**CITY PLAN COMMISSION****THURSDAY, DECEMBER 07, 2023****FILE NUMBER:** S234-016**SENIOR PLANNER:** Hema Sharma**LOCATION:** Edd Road at Garden Grove Drive, southeast corner**DATE FILED:** November 09, 2023**ZONING:** PD 1100 (Subarea A & B)**PD LINK:** Currently Not Available**CITY COUNCIL DISTRICT:** 8**SIZE OF REQUEST:** 22.946-acres**APPLICANT/OWNER:** Nan Investments, LLC. S. I. Abed

**REQUEST:** An application to create a 197-residential lots ranging in size from to 2,080 square feet to 5,128 square feet and 23-common areas from a 22.946-acre (999,511 square-foot) tract of land in City Block 8822 on property located on Edd Road at Garden Grove Drive, southeast corner.

PRELIMINARY PLAT AZIM ESTATES-TOWNHOMES
1-20 EDD RD., DALLAS, TEXAS
LOTS 1-29 BLOCK A LOTS 1-64 BLOCK B
LOTS 1-29 BLOCK C LOTS 1-8 BLOCK D
LOTS 1-14 BLOCK E LOTS 1-24 BLOCK F
LOTS 1-28 BLOCK G,
22-946-ACRE TRACT BRBNC, ALL OF
NANA INVESTMENTS, LLC
INSURUMENT NO. 2017-0019443
OFFICIAL PUBLIC REPORTS DALLAS COUNTY, TEXAS
ROBERT FERBERING SURVEY ABSTRACT NO. 716
CITY OF DALLAS DALLAS COUNTY, TEXAS
CITY PLAT FILE NO. S234-016
ENGINEERING PLANNING

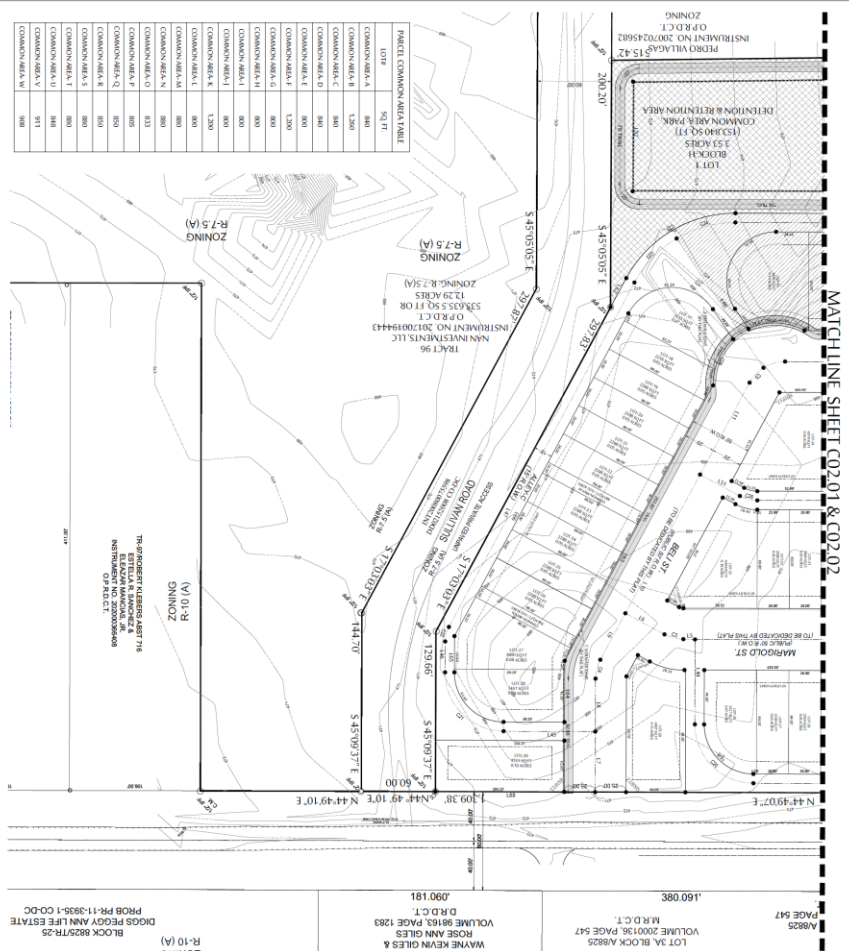
34. On the final plat, change "Garden Grove Drive" to "Garden Gove Drive" (FKA Crawford Road).
35. On the final plat, contact addressing team for appropriate name for the proposed right-of-way "Magnolia Street" already exists.

36. On the final plat, contact addressing team for appropriate name for the proposed right-of-way "Jasmine" already exists.
37. On the final plat, change "Beli ST" to "Beli Street".

38. On the final plat, change "Tube Rose ST" to "Tube Rose Street".
39. On the final plat, contact addressing team for appropriate name for the proposed right-of-way "Lotus Street" already exists.

40. On the final plat, change "Daisy ST" to "Daisy Street".
41. On the final plat, contact addressing team for appropriate name for the proposed right-of-way "Marigold" already exists.

42. On the final plat, identify the property in City Block 1/8825-7/8825. Ordinance 1A, Page 131 pages 131-148, Section 2 (passed August 13, 1872).
